LONG ISLAND LIGHTING COMPANY

(Shoreham Nuclear Power  
Station, Unit 1)

PREPARED DIRECT TESTIMONY OF  
RICHARD B. HUBBARD AND GREGORY C. MINOR  
ON BEHALF OF SUFFOLK COUNTY (SC)

ELECTRICAL SEPARATION

IEEE 384                      LILCO  
CABLE TRAY SEPARATION CRITERIA

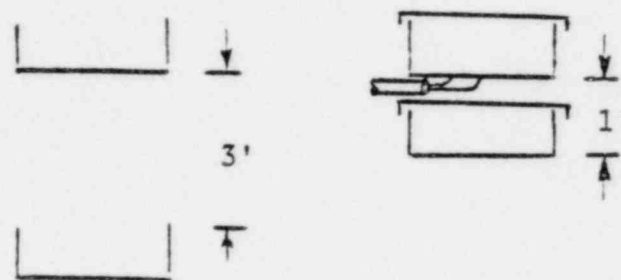
20. Second, LILCO and S&W have placed a strong reliance on alternate devices and techniques to make up for less than standard cable separation distances. For example, IEEE 384 and Reg. Guide 1.75 specify a separation distance of three feet between adjacent surfaces of stacked trays (e.g., from the bottom of the upper tray to the top of the lower tray should not be less than three feet). LILCO has set this distance at one foot from bottom-to-bottom, thus making the actual separation less than one foot - actually about eight to nine inches. The

distance is further reduced by allowing entry of exposed cables between the two separated trays.<sup>17/</sup> (See following illustration.)

To overcome these extreme reductions of separation distances, LILCO has committed to add solid covers to the cable trays.<sup>18/</sup> However, the trays are generally a ladder-type construction (i.e., open on the bottom except for metal cross rungs spaced several inches apart).<sup>19/</sup> Thus, there is still an exposure

of one surface of the tray. The IEEE 384 standard allows less than three feet vertical separation but only for enclosed raceways (i.e. trays with solid-bottom, solid-top construction).

CHECKED		EXAMPLES OF ACCEPTABLE SEPARATION OF CABLE AND CONDUIT IN THE CABLE SPREADING AREA SHAW-WALKER NUCLEAR POWER STATION UNIT 1	FIG. 9
CORRECT			
APPROVED			
DATE			
REVISIONS

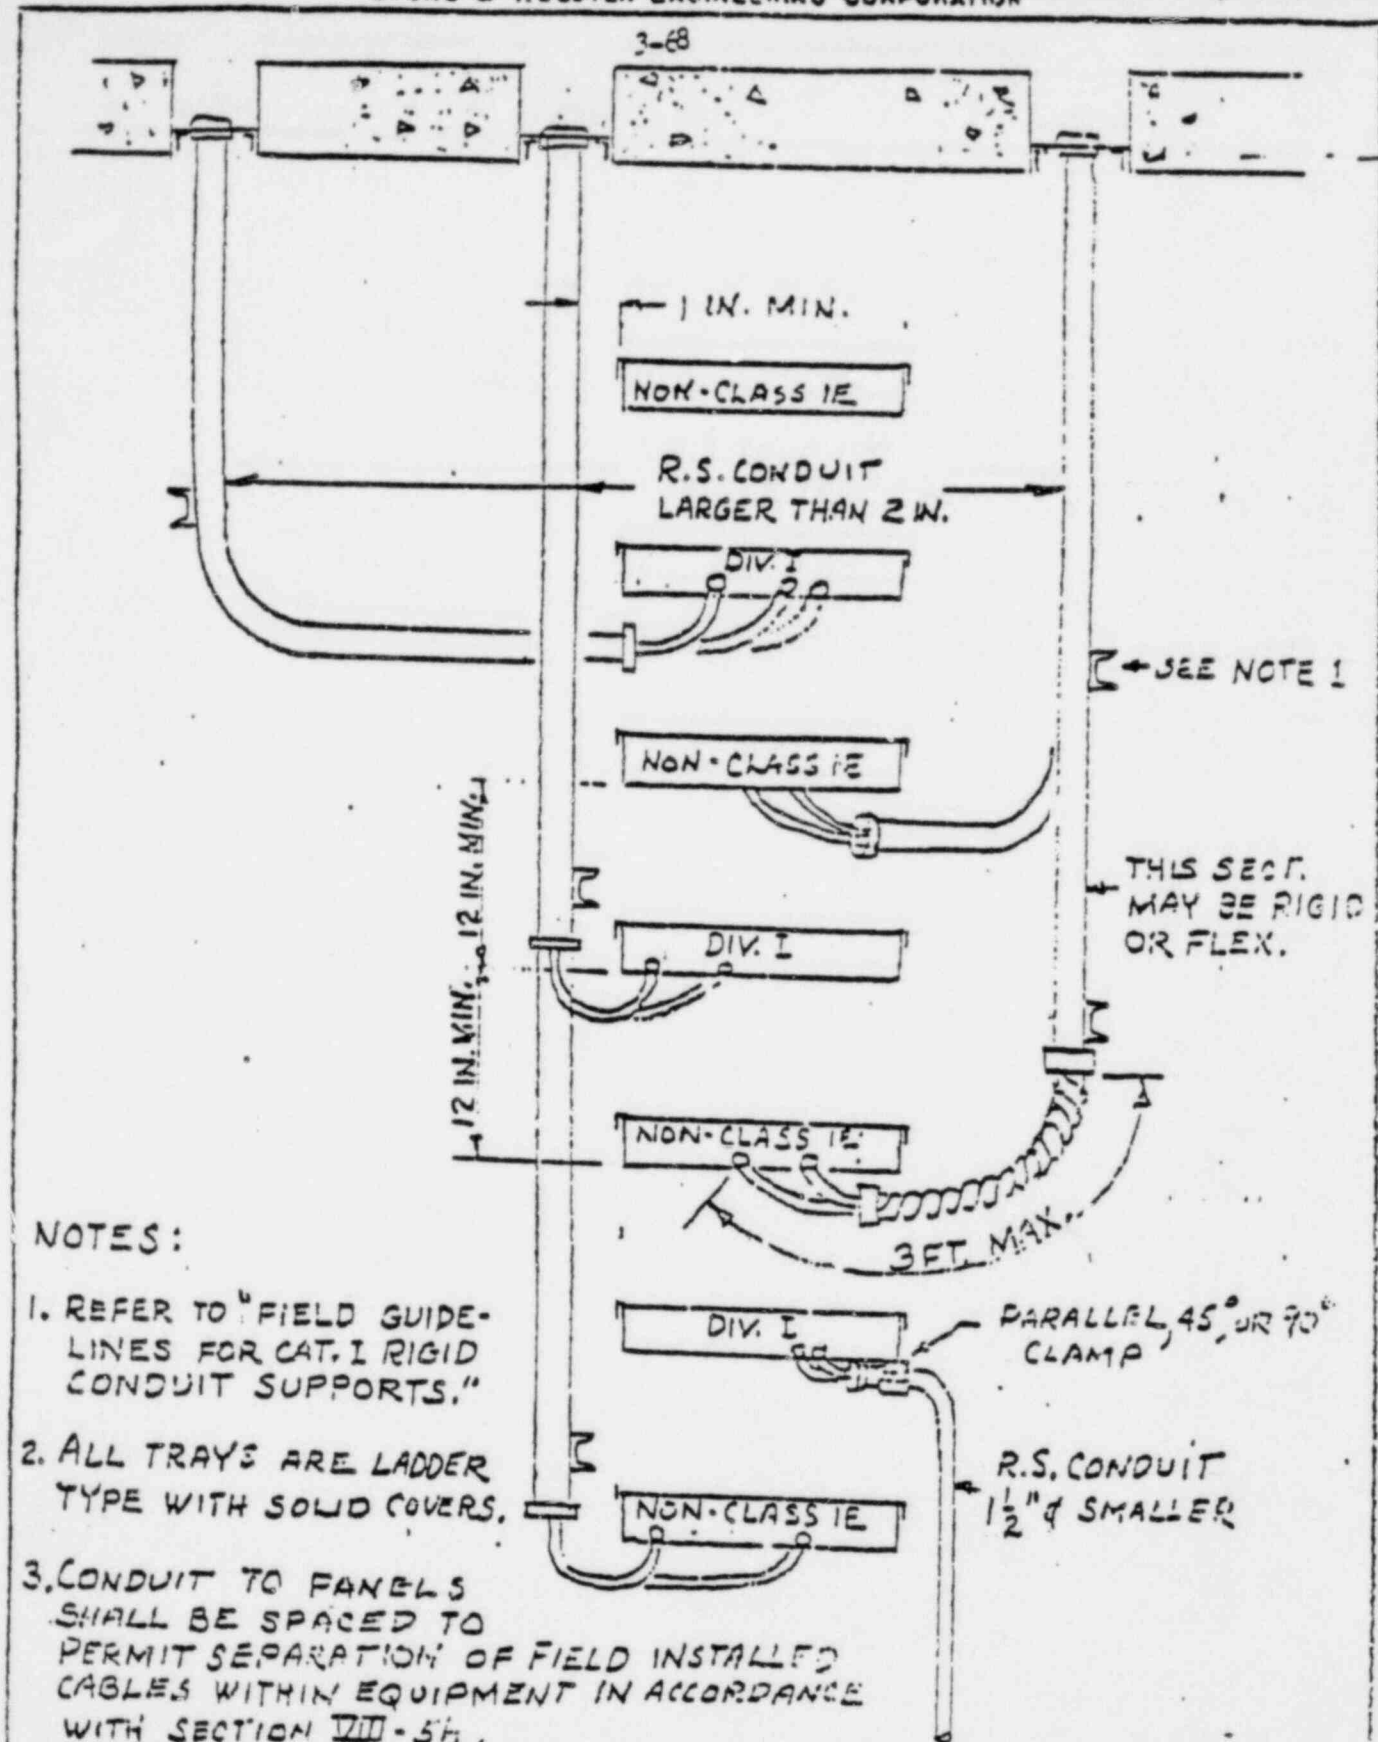
<sup>19/</sup> Ibid 17, Figure 9, note 2.
